Review of Plans: Chefman Site Plan, 29 Corporate Drive, Orangeburg, NY

Subject: **Chefman Site Plan** **PB#20-03**
Prepreliminary/Preliminary Site Plan and SEQRA
29 Corporate Drive, Orangeburg
73.19-2-8; LIO zoning district.

**PB#20-03: Chefman Site Plan
Preliminary Site Plan Approval Subject
to Conditions/ Neg. Dec.**

**Town of Orangetown Planning Board Decision
June 15, 2020
Page 1 of 14**

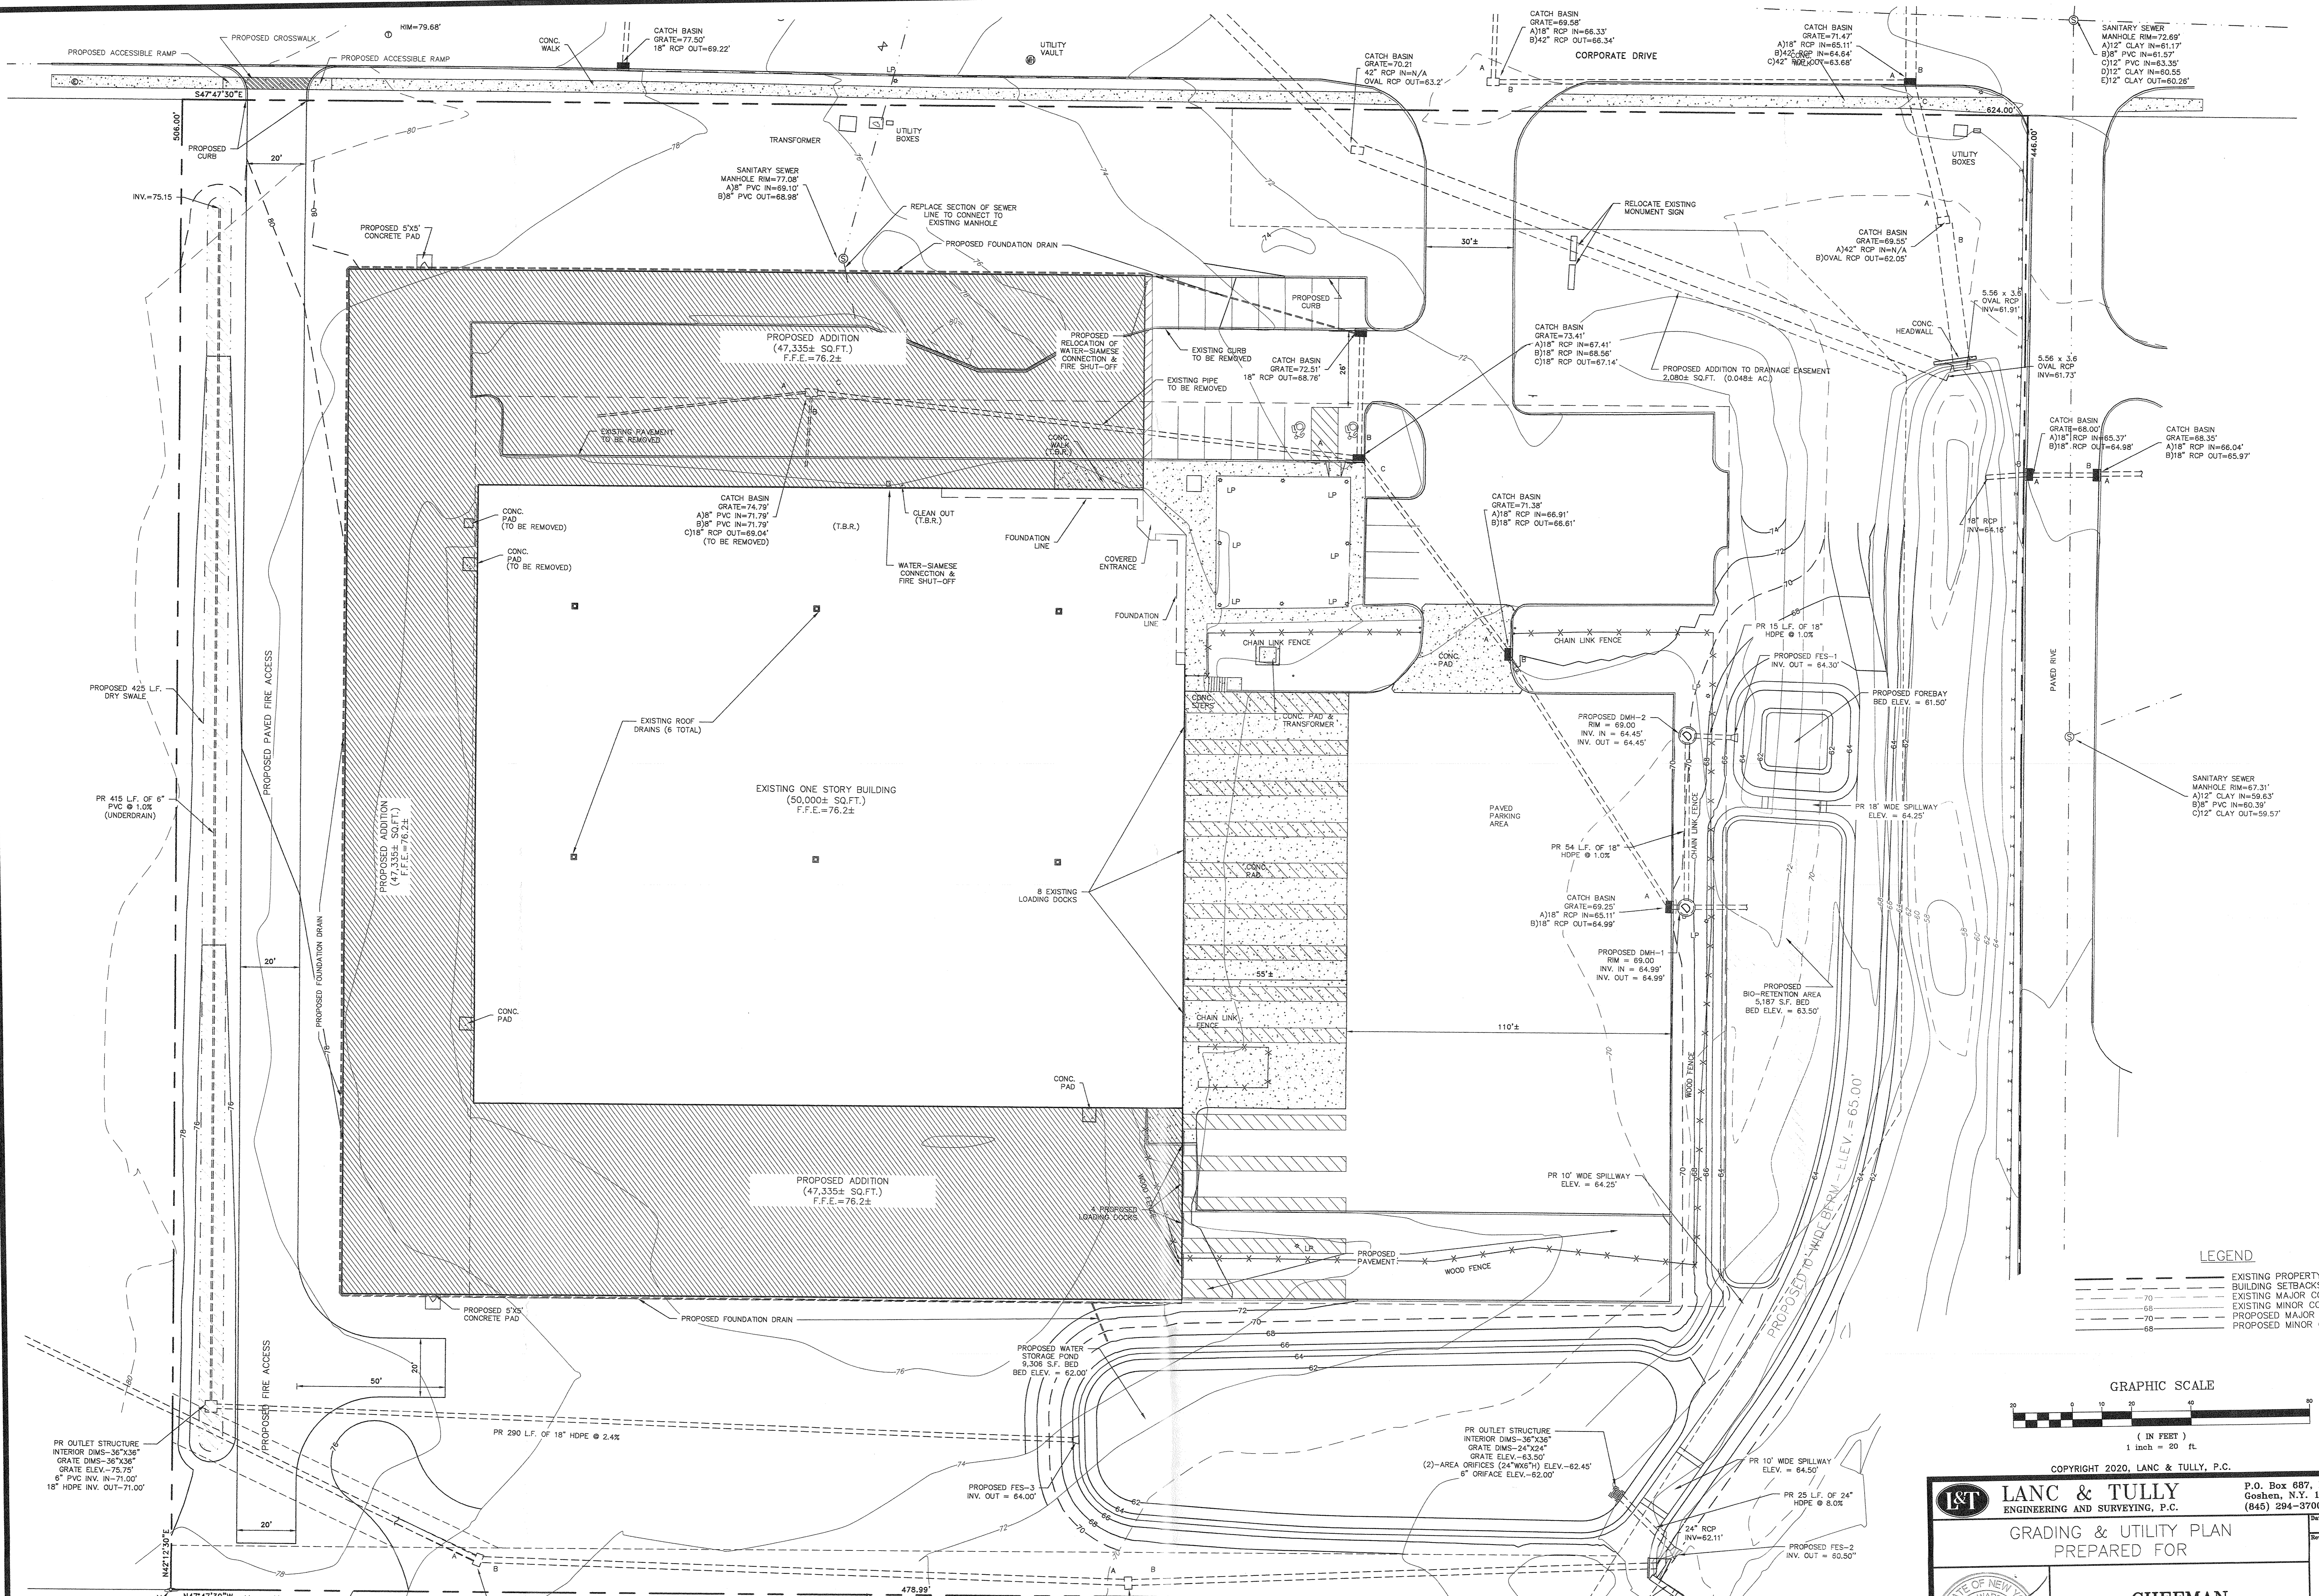
5. Clearly delineate the drainage easements on the Site Plan.
6. The existing 15-foot drainage easement along the south property line shall be shown on the Site Plan.

- 23.** The proposed limit of disturbance shall be clearly defined on the drawings. A suggestion would be to have only two drawings showing the "google" view of the property (one existing conditions and one proposed.) All other drawings shall be "standard", as per Site Plan previously submitted.

- 25.** The location of the 100 year flood zone and any flood zones shall be clearly shown, if applicable.
- 26.** This revised Site Plan contains less information than the site plan submitted for the January 15, 2020 Planning Board Meeting. For example, the existing drainage easement along the front and east side of the property is not depicted on the current drawing. All existing and proposed easements (with the associated utilities/ improvements) and dedications, shall be shown on the drawings.

- 27.** The existing 5.56 x 3.6 RCP oval stormwater drainage line, along the North east side of the property, appears to be outside of the existing Town drainage easement (as depicted on the previous site plan submission.) The applicant shall prepare and show a widening of the existing easement to encompass this stormwater drainage line. The easement shall extend at least 10 feet beyond the "southern side" of the stormwater drainage line. The proposed easement shall be submitted to the Town of Orangetown Town Attorney's Office and DEME for review and approval.

- 29.** The existing storm drain line located in the northern parking area, appears to be cut off due to the installation of the new addition. More detail shall be provided as to what is to happen with that drainage line.

- 32.** Profiles shall be added to the drawing set for all existing and proposed storm drain lines.
- 33.** The proposed contours are shown "tying into" the existing contours at right angles. This is unacceptable. The proposed contours shall tie into the existing contours in line/ gradually.
